Title		
Phoenix Theremin 2020 - Front panel		
Size	Number	Revision
A4	Humorous words of wisdom ...	1.07.19A
Date:	21. 01. 2019	Sheet of
File:	H:\FAKS\...\FrontPanel.SchDoc	Drawn By:

Phoenix theremin 2020
Prototype for a single board revision
(revision B1)

Engineered by Christopher Becker
PCB design (in progress) by Peter Nimac

Front panel connections

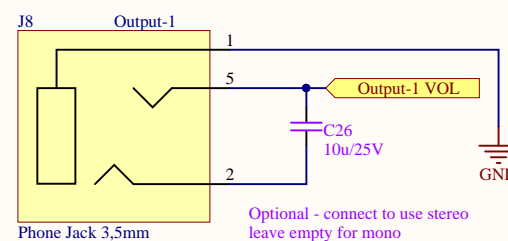
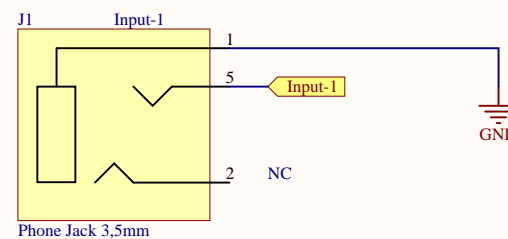
This connector should be replaced by a standard power connector. TRS jack is not really appropriate for supplying power

Title			
Size	Number		Revision
A4			
Date:	21. 01. 2019		Sheet of
File:	H:\FAKS\...\Phoenix.SchDoc		Drawn By:

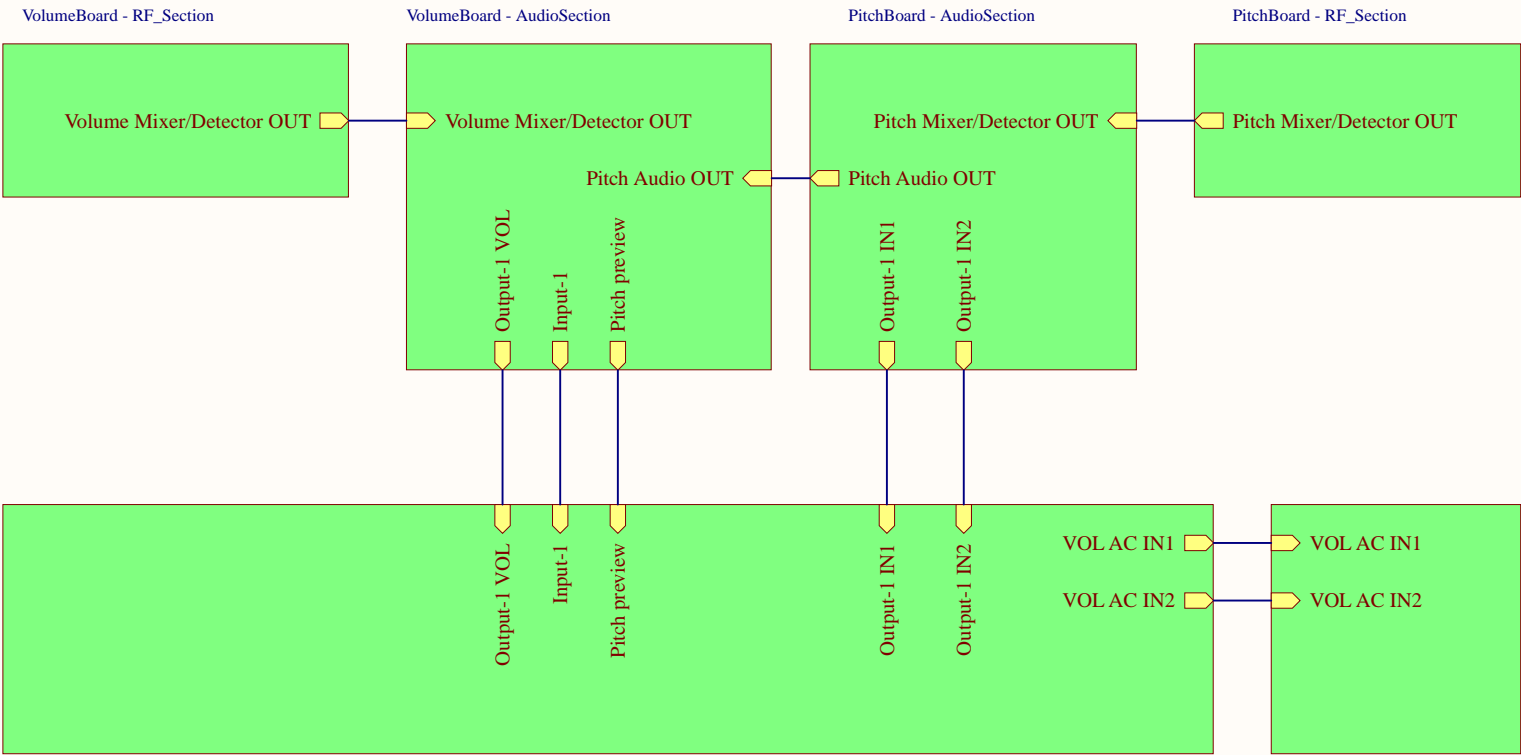
Power ports for pitch board are not mandatory and are only needed in the case of pitch board being used separately, without the volume board. In that case the pitch board needs it's own power supply.

This field will be edited once I figure out how to change the layout of the black area

Pitch Mixer/Detector OUT

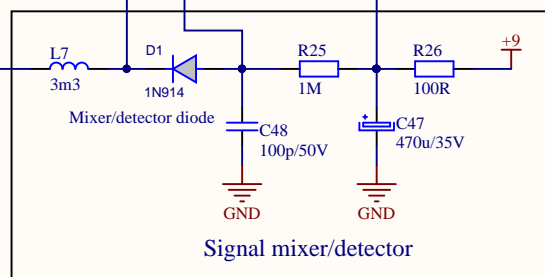
How should I name the connector in the place of Ant2_P? This is the marking I see on the website.

Title		
Phoenix Theremin 2020 - Pitch board, RF section		
Size	Number	Revision
A4	Theoretically speaking, ...	1.07.19A
Date:	21. 01. 2019	Sheet of
File:	H:\FAKS\...PitchBoard - RF_Section.Sch	Drawn By:

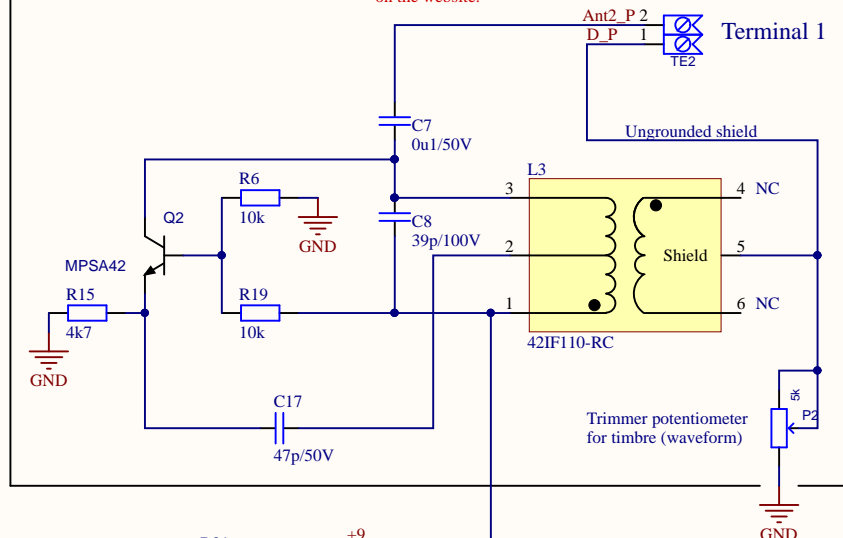
C-D is a port for panel mounted 2k potentiometer P5A used for signal waveform adjustment. P5A is mounted in parallel to P5

P2 and P3 are used to balance thermal drift they are not mandatory however and may be left out, as they will be bypassed by R9 and R27.

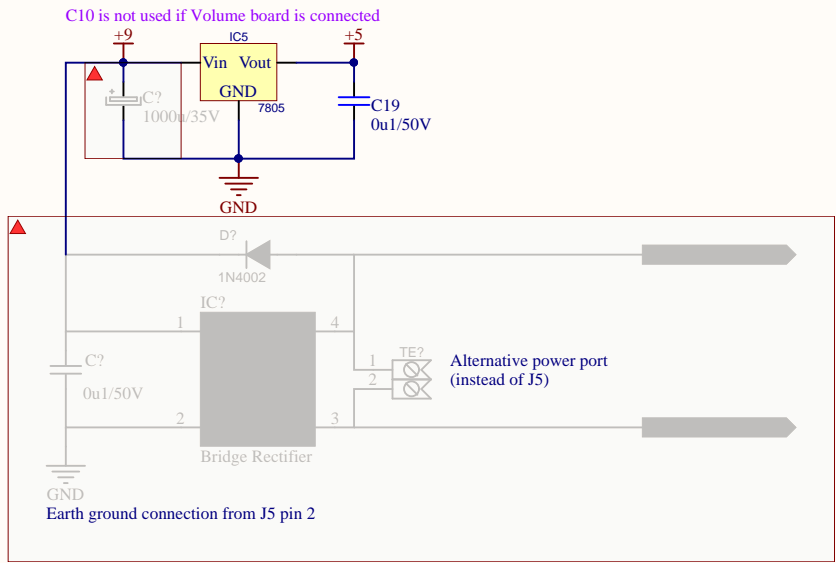
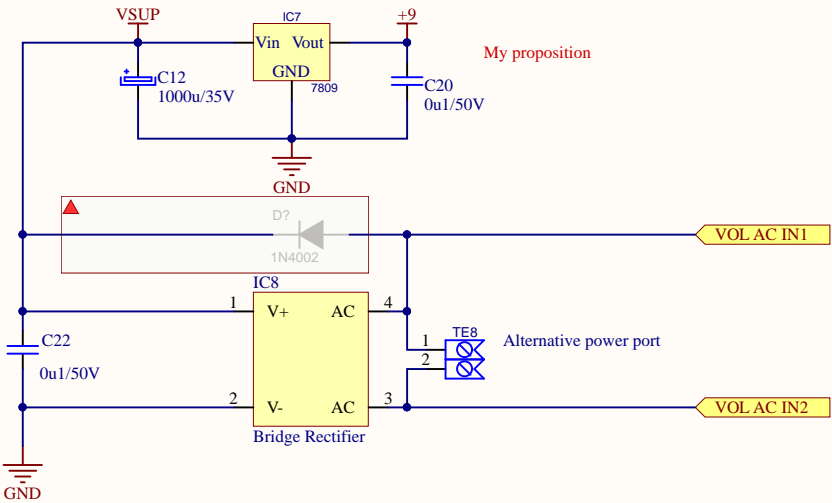
I will remove the greyed out areas.
I will however, make a separate schematic for the 2 board variant and leave the appropriate parts of the circuit on the schematic.

Title			
Phoenix Theremin 2020 - Power supply			
Size	Number	Revision	
A4	... practice and theory ...	1.07.19A	
Date:	21. 01. 2019	Sheet	of
File:	H:\FAKS\...\PowerSupply.SchDoc	Drawn By:

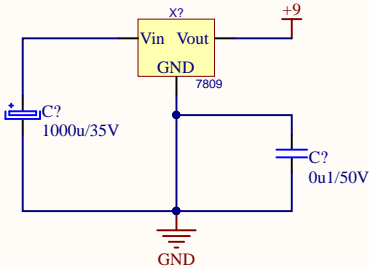
I still see this and it doesn't look right to me.
Did you forgot to reupload a new image
Or is this intended?

Title		
Phoenix Theremin 2020 - Volume board, Audio section		
Size	Number	Revision
A4	... are both ...	1.07.19A
Date:	21. 01. 2019	Sheet of
File:	H:\FAKS\VolumeBoard - AudioSection	Sheet By:

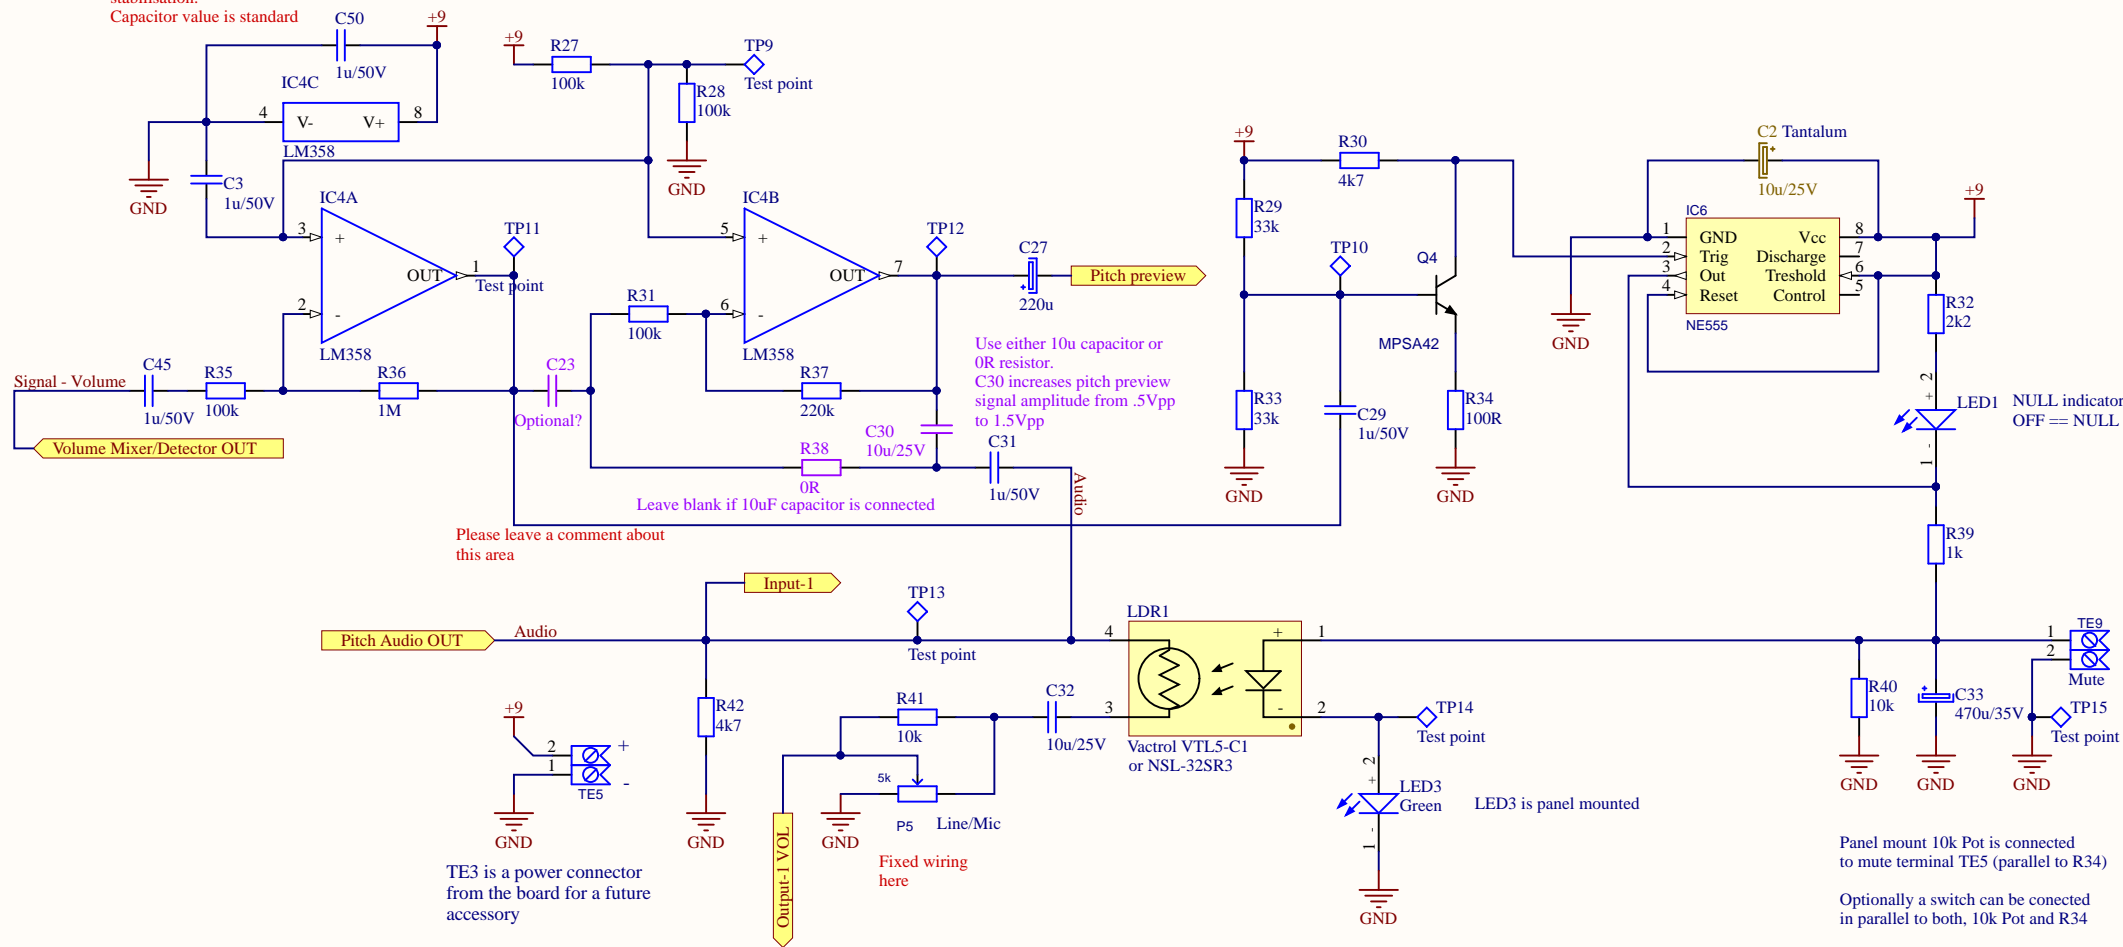
ADDED - 1u/50V Blocking capacitor for OPAMP voltage stabilisation.
Capacitor value is standard
